XM Satellite Radio Inoperative Until Ignition Key Is Cycled

TSB REVISION NOTICE

March 30, 2010 Rev1:

- **Applicability has been updated to include additional 2010 – 2011 model year Toyota vehicles.**

Figure 1. Sample of Countermeasure Part Label

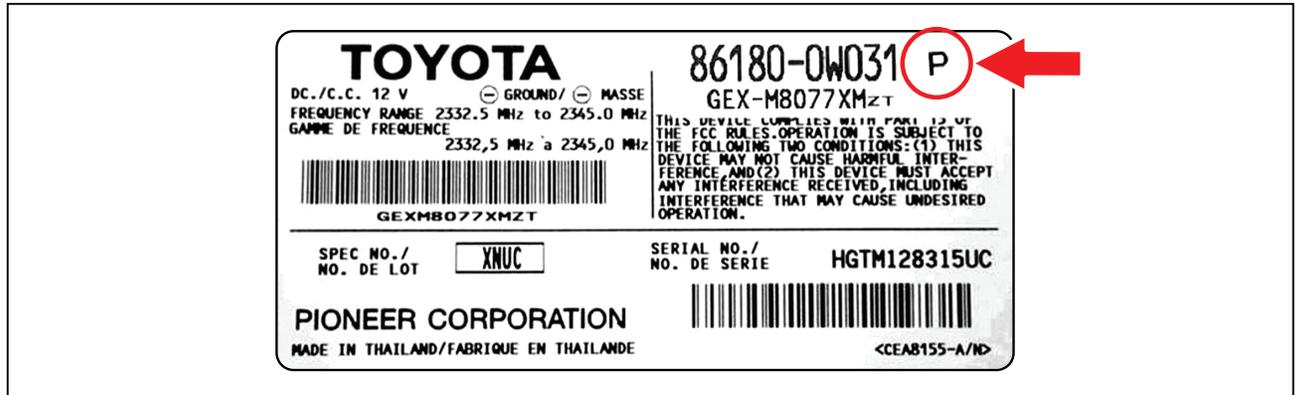
Countermeasure parts have a “P” marking on the parts label following the Toyota part number (see Figure 1).
